产品停产通知

限位开关

发布日期
2016年9月1日
No. SD-L-1607003

2回路限位开关 WL-N 系列的停产通知。

内置开关的安装螺钉已变更

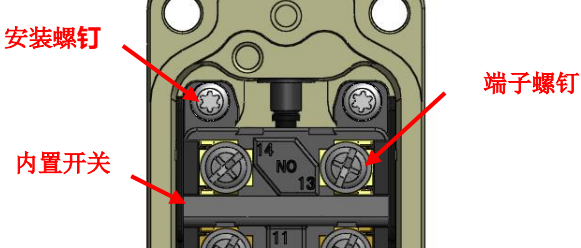
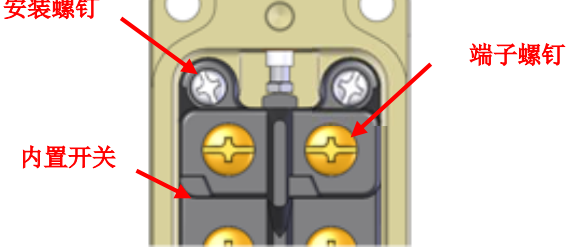
停产产品 WL-N	推荐的替代产品 WL
端子螺钉: M3.5 (材质: 钢带方形垫圈) 内置开关的安装螺钉: M3 (十字螺钉) 	端子螺钉: M4 (材质: 黄铜带齿垫圈) 内置开关的安装螺钉: M3 (+-螺钉)

差异点 4: 隔板变更

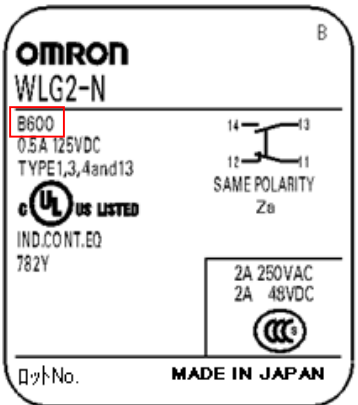
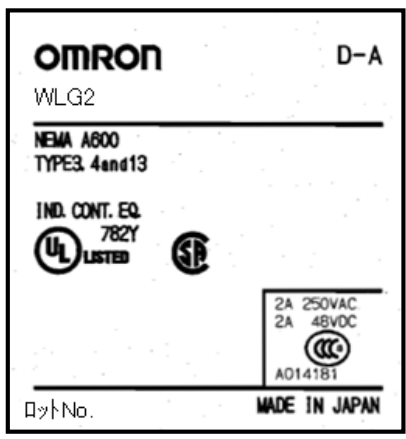
停产产品 WL-N	推荐的替代产品 WL
<p>用绝缘护罩和密封盖确保绝缘距离</p>  <p>内置开关的密封盖和绝缘护罩用于确保绝缘距离。</p>	<p>用隔板确保绝缘距离</p>

差异点 7: 型号已整合。因此动作特性已变更

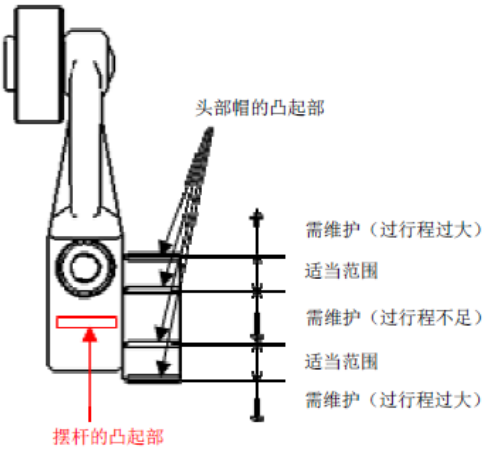
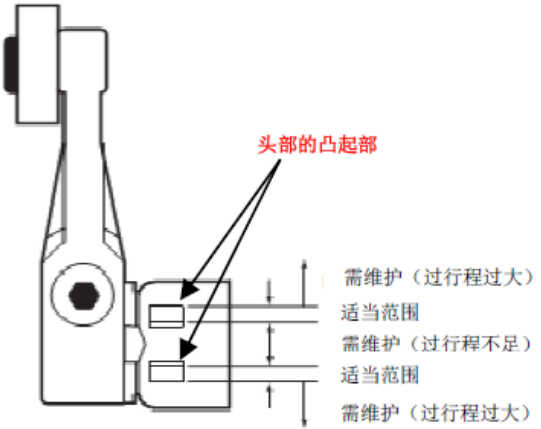
停产产品 WL-N	示例: WLG2-N, WLGCA2-N		
	项目	WLG2-N	WLGCA2-N
	动作力OF最大	13.34N	13.34N
	回复力RF最小	1.18N	1.18N
	过行程OT最小	80°	80°
推荐的替代产品 WL	示例: WLG2, WLGCA2		
	项目	WLG2	WLGCA2
	动作力OF最大	9.81N	13.34N
	回复力RF最小	0.98N	1.47N
	过行程OT最小	65°	40°

差异点 9: 电气负载的种类已整合

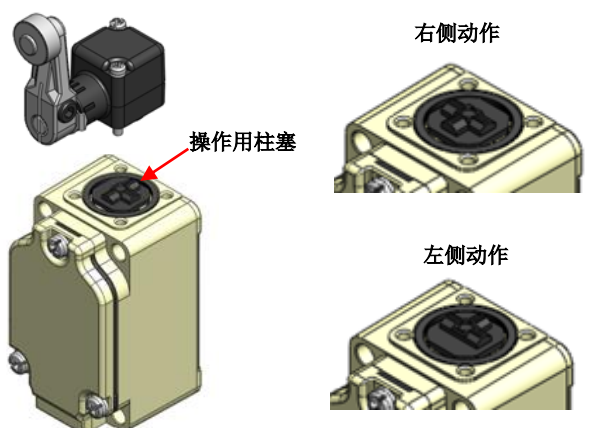
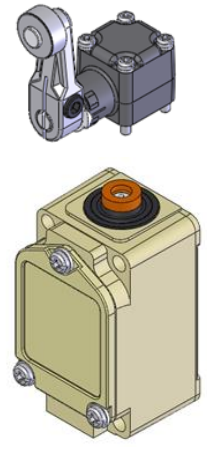
停产产品 WL-N	推荐的替代产品 WL
示例：WLG2-N (一般负载/ 微小负载)	示例：WLG2 (一般负载) WL01G2 (微小负载)

差异点 13: 防腐型的产品标志已变更

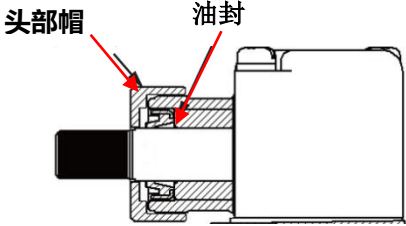
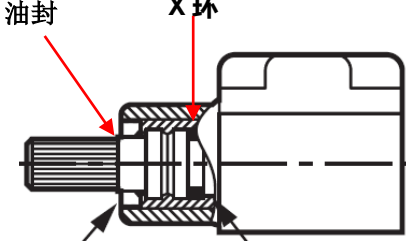
<p>停产产品 WL-N</p>	<p>推荐的替代产品 WL</p>
<p>WL*-RP-N 激光标志</p> 	<p>WL*-RP (注1) 铭板</p>

注 1: 不含密封型 (-RP40、-RP60)
